DEVELOPMENT ASSESSMENT REPORT
Shire of Augusta Margaret River
30 May to 5 June 2024

Date Rec'd	Reference No.	Address	Proposal	Recommendation
PLANNING				
8/03/2024	P224177	Unit 2/7 (Lot 1) Acacia Court, Cowaramup	Grouped Dwelling	Conditional Approval
19/02/2024	P224126	12 (Lot 408) Maclaren Crescent, Margaret River	Single Dwelling and Ancillary Dwelling	Conditional Approval

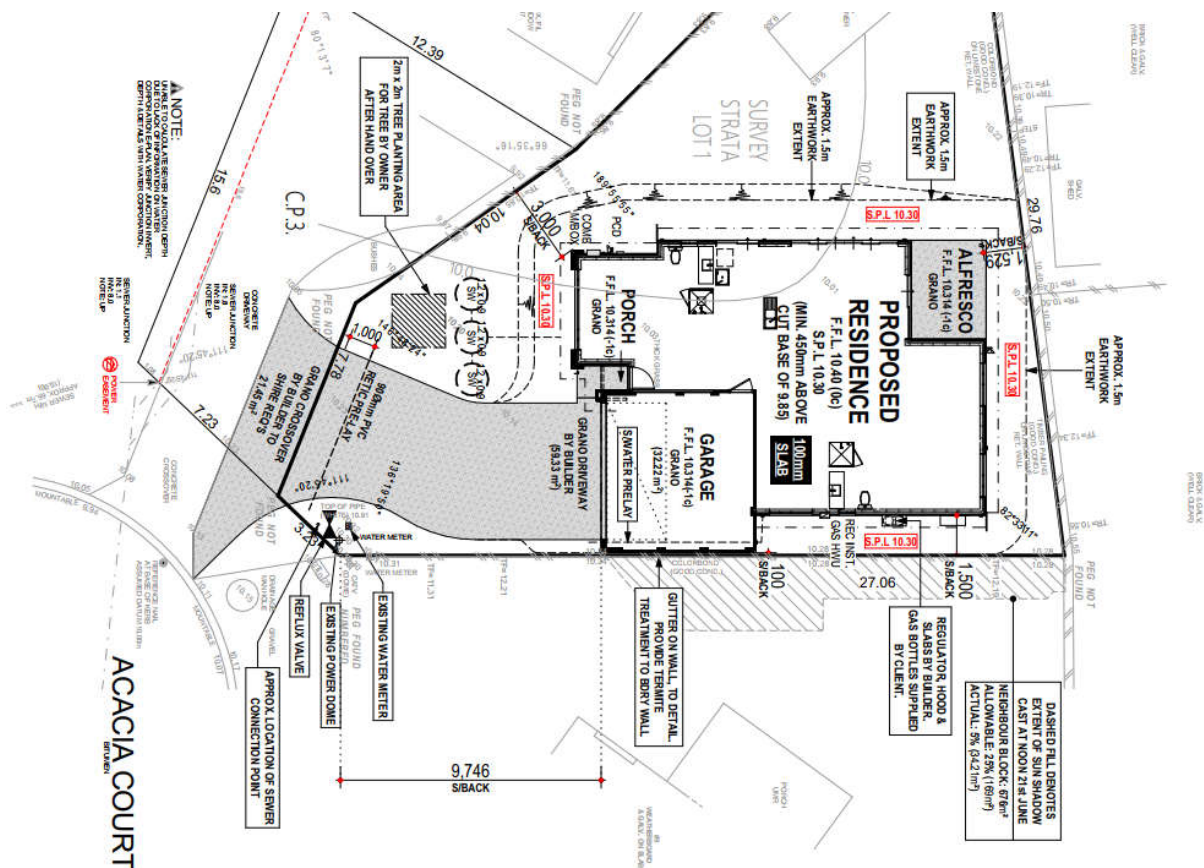
The owners of the neighbouring property (9 Acacia Court) objected to the boundary wall, stating the wall would create overshadowing and impact the availability of sunlight to their living spaces. The property owners were provided with an overshadowing diagram depicting the extent of overshadowing and were advised a condition would be applied to ensure the wall was finished to a standard they deemed appropriate. The property owners wished to maintain their objection to the boundary wall.

A maximum of 1m of additional shading will be generated by the boundary wall as per the overshadowing diagram provided by Summit Homes. The boundary wall will not cause overshadowing to the habitable areas at 9 Acacia Court, with the alfresco area situated 4m from the boundary and living room situated 6m from the boundary (see below)

There is ample outdoor space at 9 Acacia Court that will not be affected by the boundary wall. The proposed wall is of a non-imposing height at 0.3m over the allowable fence height as per LPP4 (Boundary Fencing). There will be no impact to overlooking or loss of privacy at 9 Acacia Court due to the boundary wall.

It should be noted that a carport could be constructed up to the boundary, generating a similar overshadowing impact.

Figure 1: Amended south elevation with hipped roofs

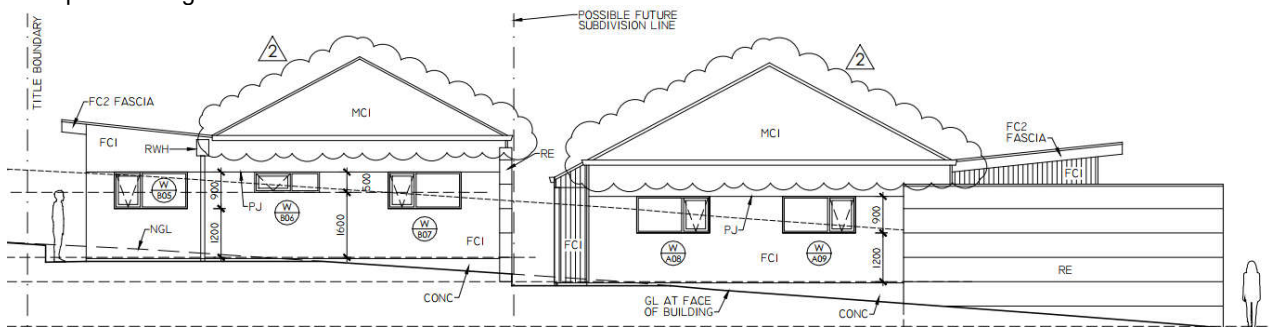
Community Engagement		
Submitter	Submitter Comments	Officer Comments
Private Submitter 1	<p>Object to proposed reduced setback on southern boundary from 2.5m to 1.2m. This change will affect my amenity and privacy. This area of my lot is proposed as an outdoor living area as part of my solar passive design home. I purchased the lot on the understanding that the standard setback would be continued and always apply.</p>	Noted. See Discussion section below.
Private Submitter 2	<p>Object to the proposed rear (south) lot boundary setback of 1.2m (in-lieu of 2.5m). I bought the adjoining lot 409 with the understanding that the setback standards of 2.5m would be adhered with. The proposed reduced setback distance will impact my amenity and privacy. Can I please be notified of the decision on this matter, thanks.</p>	Noted. See Discussion section below.

Advertising was completed during the assessment with letters outlining variations to the relevant planning framework sent to three (3) neighbours surrounding the property. Two (2) submissions were received noting that both submissions were received from the same property. The objections received related to the proposed setback for the dwelling and ancillary dwelling to the rear southern lot boundary.

In response to the issues raised in the submissions the applicant submitted amended plans with the southern roofs hipped as depicted in Figure 1 below:

This essentially reduced the required setback under the R-Codes from 2.5m (as originally proposed) to 1.5m. Therefore, a variation to the deemed to comply requirements of Clause 5.1.3 with a rear (south) lot boundary setback of 1.2m in lieu of 1.5m. The following design principles are therefore applicable to the proposal:

- Amended plans submitted in response to comments received from southern adjoining landowners, ameliorating the bulk and scale of the gable walls to the single dwelling and ancillary dwelling on the south elevation with the hipped roofs providing increased articulation of the south façade and reducing any perception of building bulk as viewed from the south.
- The proposed dwellings are both single storey with minimal retaining/fill used responding to the natural levels of the site reducing any undue impact in terms of building bulk and scale.
- The proposal is compliant with the deemed-to-comply visual privacy provisions of the R-Codes.
- The proposal is compliant with the deemed-to-comply solar access for adjoining sites provisions of the R-Codes.
